Access Compliance Report

Public Rights-of-Way

(Curb Ramps)

Intersection ID: 5062	Main Street: CLIFFVALE_CT	Cross Street: HEDGECREST_PL	Location: SE
ADA ID: 7D41ADD45B63	Ramp Type: Directional1	Initial Pass/Fail: Fail	Overall Compliance: No
			Severity Score: 33.75

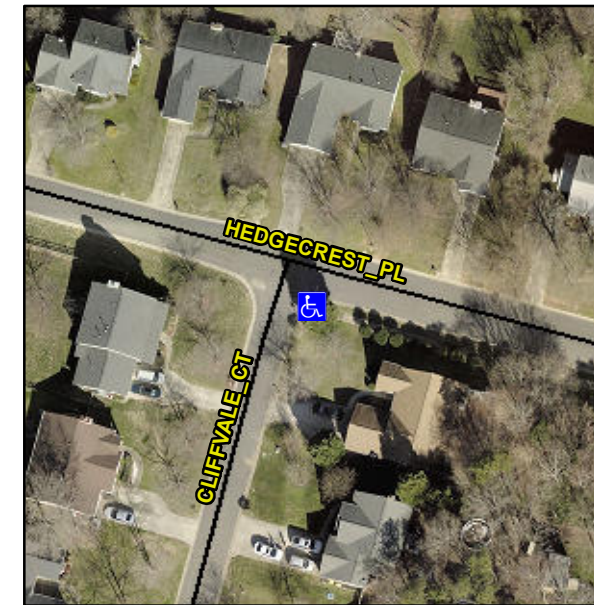
R304.5.1, R304.2.2

Compliance	Description	Data	Compliance	Description	Data
N/A	Ramp Length (in)	50.0	N/A	Grade Break?	N/A
No	Ramp Width (in)	43.0	N/A	Grade Break Slope (%)	0.0
No	Ramp Slope (%)	18.0	N/A	Grade Break XSlope (%)	0.0
Yes	Ramp XSlope (%)	1.8			
N/A	Flare Type LT	N/A	N/A	Flare Type RT	N/A
N/A	Flare Slope LT (%)	N/A	N/A	Flare Slope RT (%)	0.0
N/A	Flare Traversable LT?	N/A	N/A	Flare Traversable RT?	N/A
N/A	Landing Length (in)	0.0	N/A	DWS Provided?	N/A
N/A	Landing Width (in)	0.0	N/A	DWS Contrast?	N/A
N/A	Landing Slope (%)	0.0	N/A	DWS Length (in)	N/A
N/A	Landing X Slope (%)	0.0	N/A	DWS Full Width?	N/A
N/A	Landing Curb? (Y/N)	N/A	N/A	DWS Offset LT (in)	N/A
N/A	Shared Landing?	N/A	N/A	DWS Offset RT (in)	N/A
N/A	Gutter Ponding?	0.0	N/A	Gutter Slope (%)	N/A
N/A	Gutter Lip Ht (in)	0.0	N/A	Gutter X Slope (%)	N/A
N/A	Painted X Walk1?	No		Road Slope (%)	1.0
	X Walk 1 Direction	To W		Road X Slope (%)	1.0
	X Walk 1 Width (in)	N/A		Clear Space?	N/A

Remove & Replace Entire Ramp.
